PLAN CORRECTIONS REPORT HPB20-0444

Historic Preservation Board

Project: BANCROFT EXECUTIVE OFFICE SUITES BUILDING RESTORATION
1501 Collins Ave Miami Beach, FL 33139

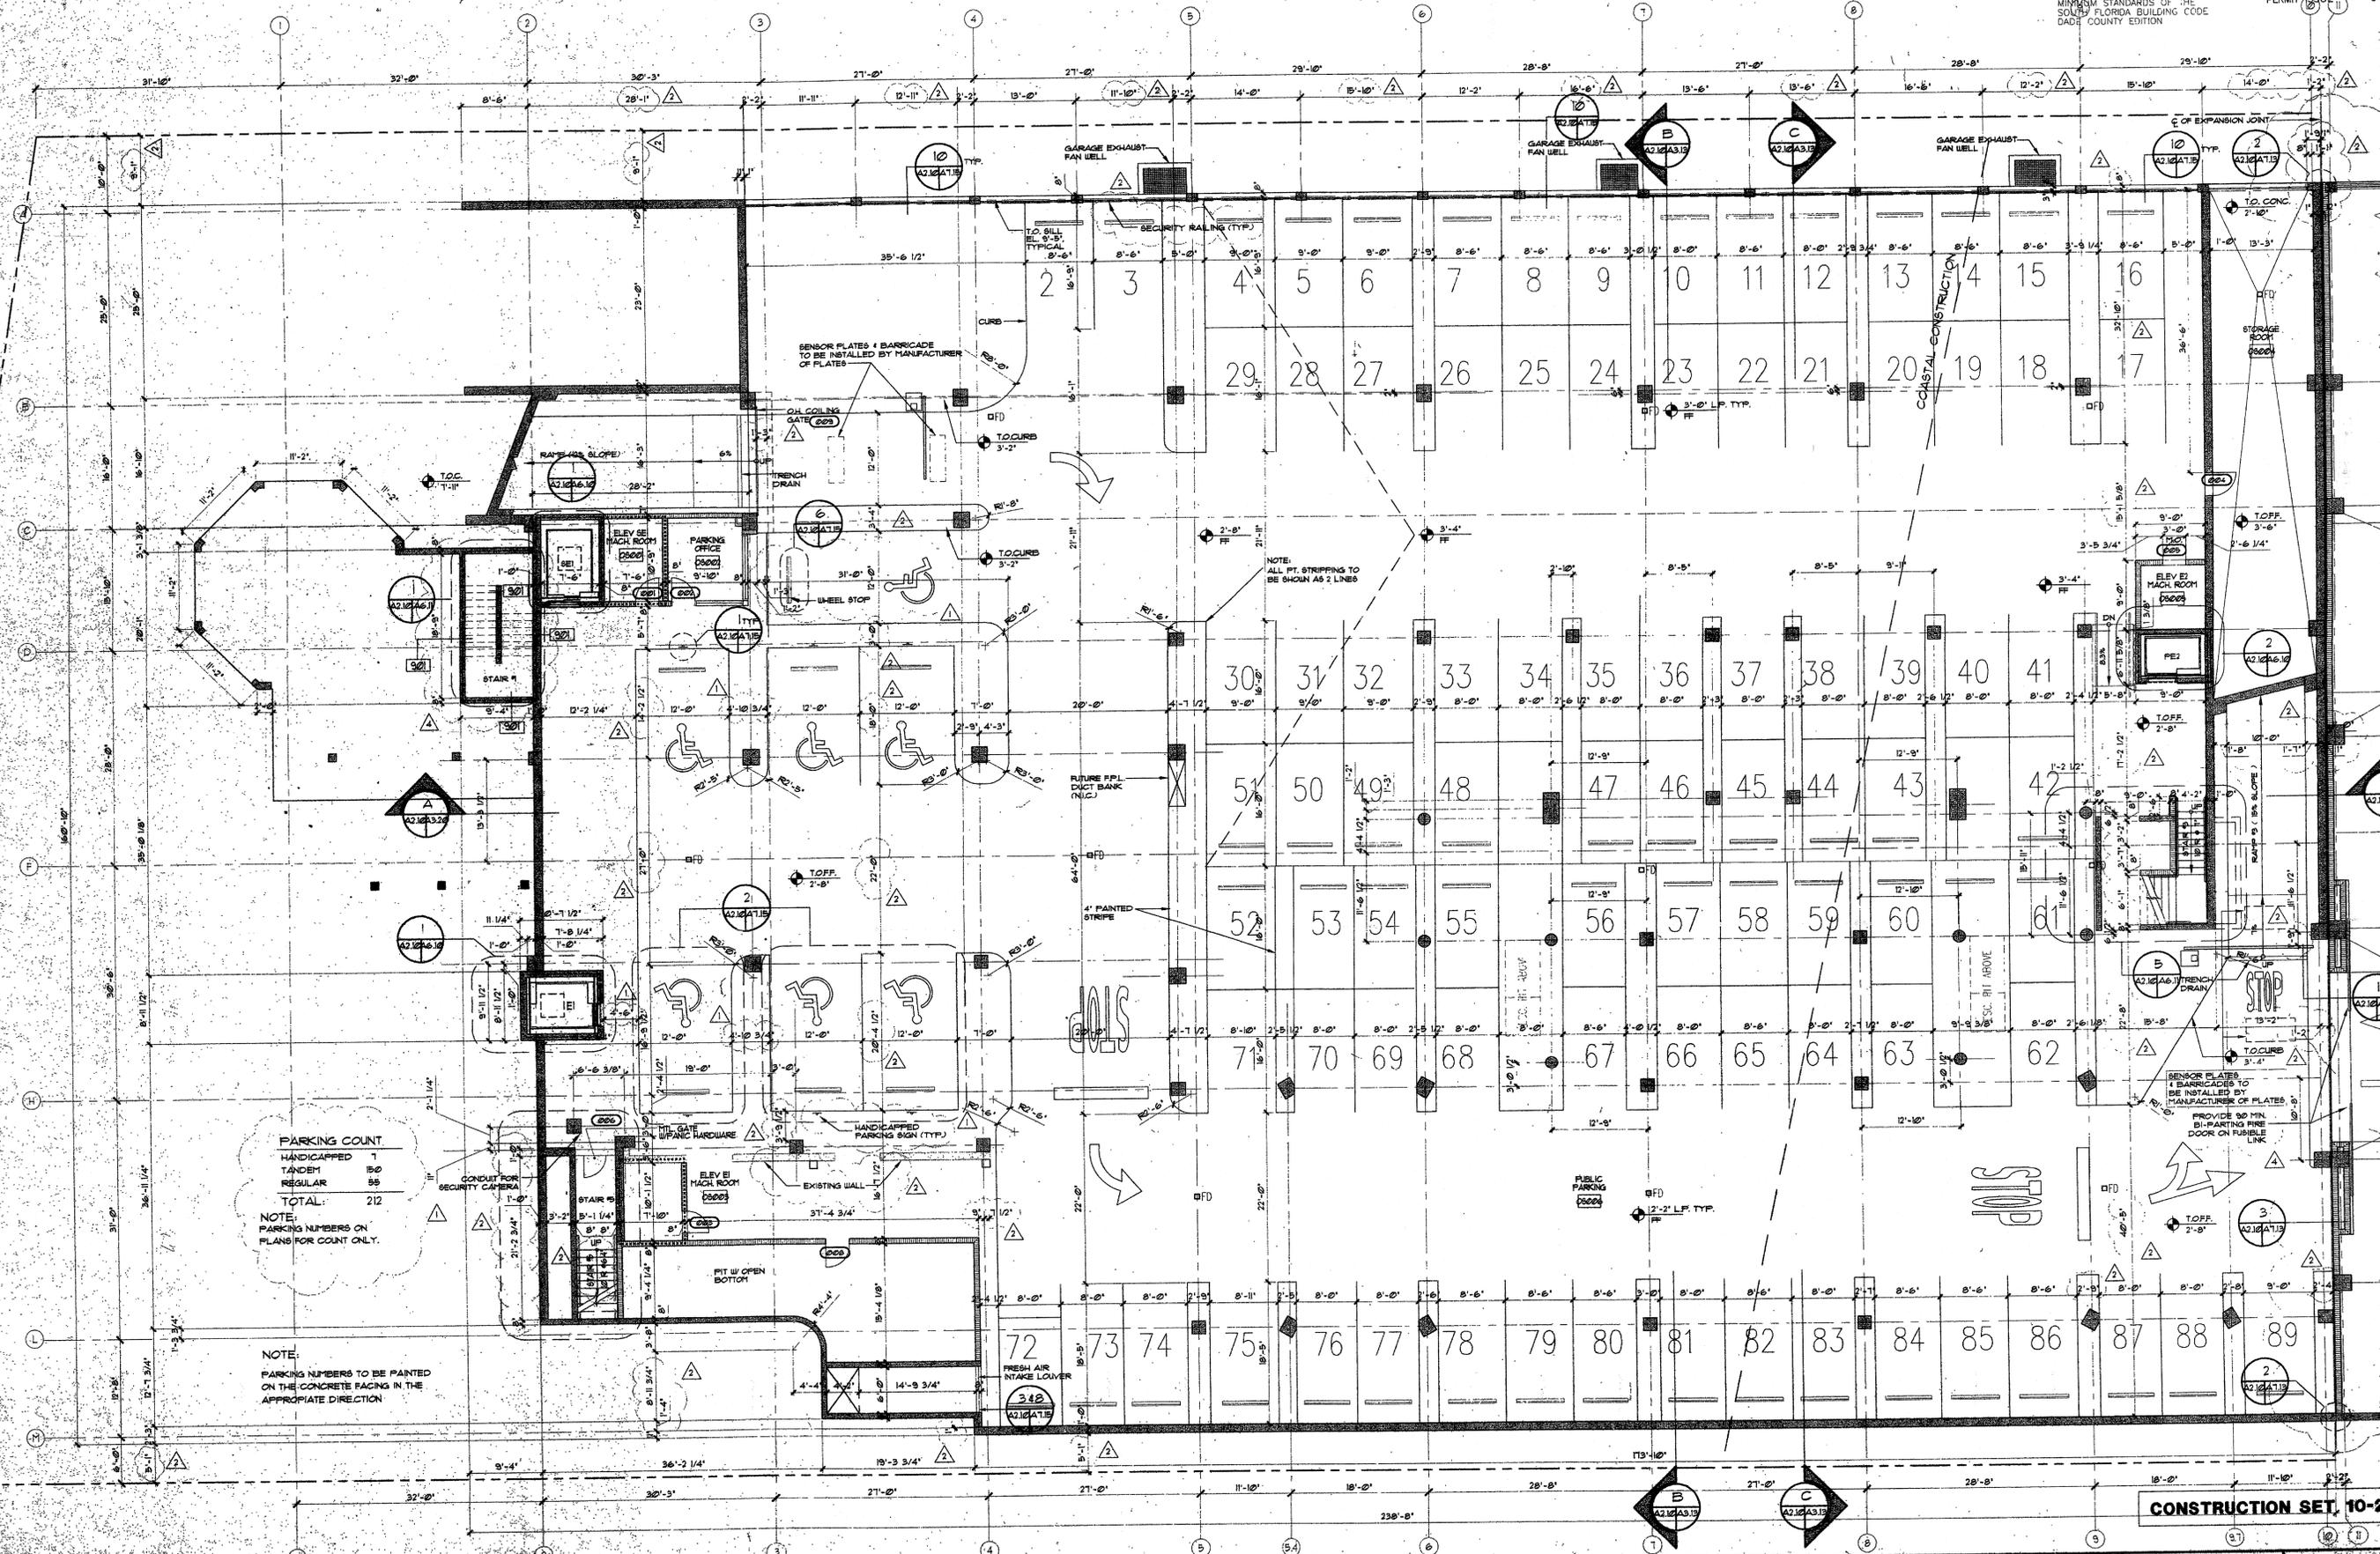
Provide a Tree Disposition Plan. Removal of any non-invasive trees with a 6” DBH or greater from private property and any non-invasive trees with a 3” DBH or greater from public property would require a Tree Removal Permit from the City of Miami Beach Urban Forestry Division. Plan should address tree mitigation requirements as prescribed by code.

Provide a Tree Survey prepared by a Professional Land Surveyor listing common names, size, and location of existing trees and palms with a DBH of 6” or greater in private property and 3” DBH or greater in the public ROW

RESPONSE: Please note that an Existing Tree Survey + Disposition Plan and Tree Mitigation summary has been provided in accordance to Ch. 46. Please see Sheet L3.00 + L3.01 for additional information.

RESPONSE: Please note that an updated Tree Survey prepared by J.Hernandez & Associates Inc. dated 02.03.21 has been provided. Please see Sheet L3.00 + L3.01 for additional information.
